## IDAP REPORT

<b>Property:</b>	4 Strathlora Street STRATHFIELD Lot: 162 DP: 11856 DA2021/122
<b>Proposal:</b>	Demolition of existing buildings, tree removal and construction of a two (2) storey dwelling house and in-ground swimming pool.
<b>Applicant:</b>	R Moussawel
<b>Owner:</b>	R El-Kaderi
<b>Date of lodgement:</b>	22 June 2021
<b>Notification period:</b>	6 July – 20 July 2021
<b>Submissions received:</b>	One (1) written submission received
<b>Assessment officer:</b>	L Gibson
<b>Estimated cost of works:</b>	\$1,284,150.00
<b>Zoning:</b>	R2-Low Density Residential - SLEP 2012
<b>Heritage:</b>	No
<b>Flood affected:</b>	No
<b>Is a Clause 4.6 Variation Proposed:</b>	No
<b>RECOMMENDATION OF OFFICER:</b>	<b>APPROVAL</b>

**Figure 8: Site Plan of proposal.**

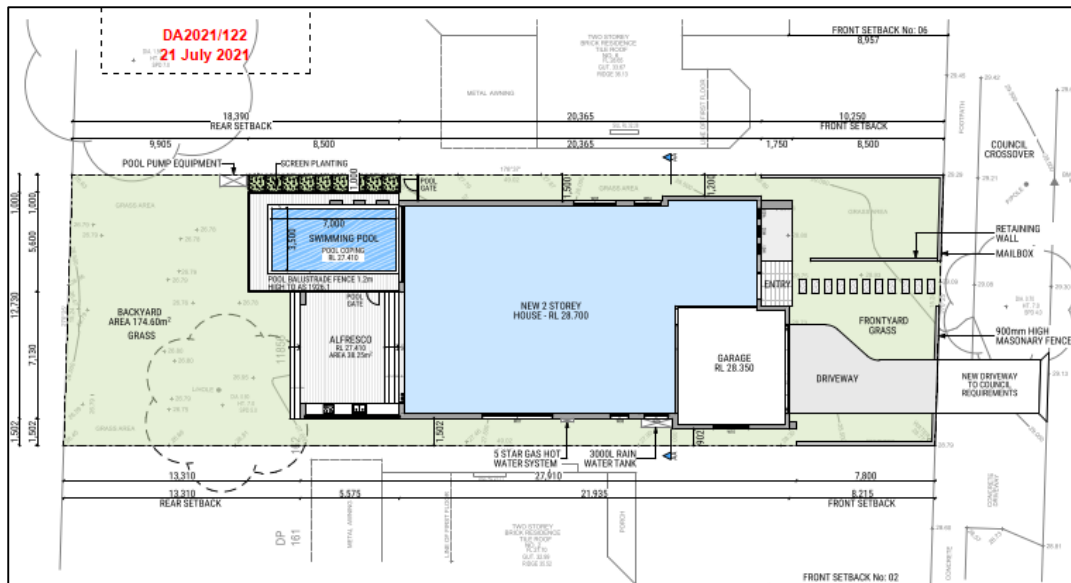
The proposed development results in an 8.5m building setback which presents a 500mm departure from the minimum front setback requirements as prescribed above. Figure 8 below depicts the siting of the building in relation to existing dwellings adjoining the site at 2 and 6 Strathlora St. An 8.9m front setback is provided by the dwelling at 6 Strathlora and a 9.11m front setback is provided by the dwelling at 2 Strathlora St. The 8.5m front setback proposed for the site is a result of the front balcony and blade walls to the façade of the dwelling. The remaining portions of the dwelling achieve a front setback of 10m which aligns more closely with the adjoining dwellings as well as all dwellings on the southern side of the street which display a similar front setback alignment.

The proposal seeks a 900mm setback from the eastern side boundary of the site. This departure is contained to the garage only with the remaining ground and first floor setbacks achieving a 1.5m setback from the eastern side boundary. The intent of the setback controls is to encourage articulation of the built form as well as to enable view corridors to be maintained between dwellings. The site provides varying building elements, setbacks, building heights and colours to break the bulk of the dwelling and achieve articulation throughout. Further, the 16.6m front setback provided by the western portion of the dwelling at 2 Strathlora St enables considerable building separation to be achieved between buildings.

Whilst the proposal does not numerically comply with the minimum deep soil landscaping requirements, the proposed design provides ample consolidated deep soil zones in the front and rear portions of the site. These spaces are considered suitable in relation to the scale of the development (refer to Figure 8 above for reference).

Overall, the proposed front and side setbacks, whilst not numerically compliant, are considered appropriate to the site and will ensure a continuation of the building rhythm in the streetscape is maintained. The departures are considered acceptable in this instance.

**Figure 10: Proposed Front Fence Elevation Plan**

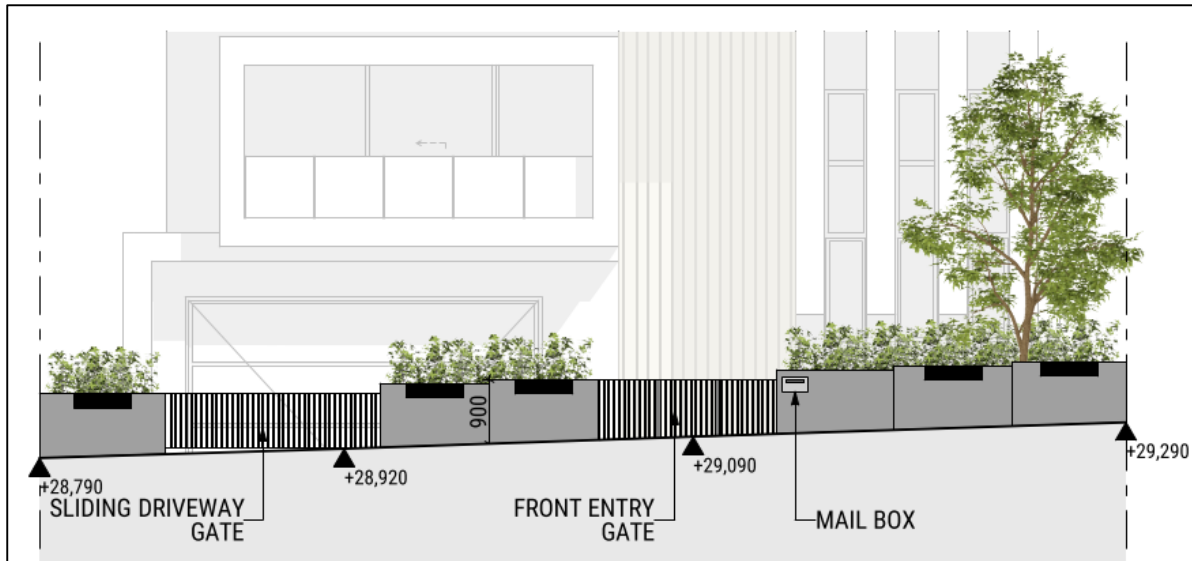
The proposal includes a solid rendered fence with some metal batten infill to a height of 900mm (refer to Figure 10 for reference). Whilst this exceeds the maximum 700mm fence height as per the SCDP 2005, the design is consistent with that of existing fence heights in the street which have been constructed to a height of 1.8m. Overall, the proposed fencing is considered to be sympathetic to the existing fence heights in the street whilst also being sympathetic to the design of the dwelling and is therefore acceptable in this instance.

**Figure 11: Ground Floor Plan showing basement floorplate (highlighted in yellow).**

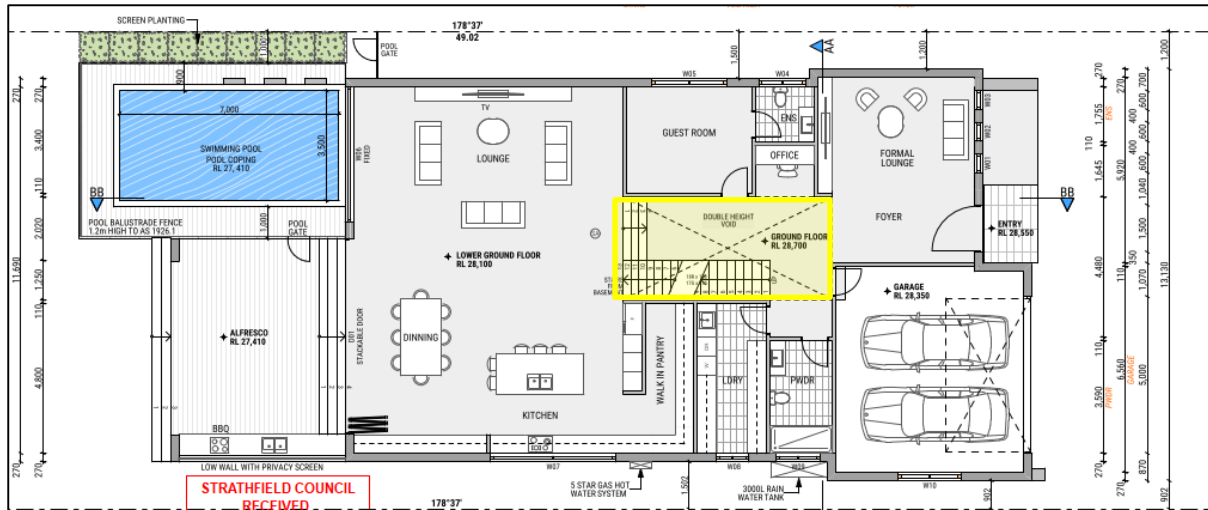
The proposed development satisfies the relevant objectives and controls of the SCDP 2005 in that it provides the minimum number of required parking spaces and adequate vehicular access provisions. At-grade parking is provided via an attached garage. A basement has been provided which will be accessed internally via the ground floor stairs only. The basement extends to a maximum of 700mm above the ground due to the sloping nature of the site and fits well within the building footprint. The basement provides a floor to ceiling height of 2.4m which is considered acceptable. The figure below demonstrates the basement floorplate (highlighted in yellow) in relation to the ground floor plan / building envelope.
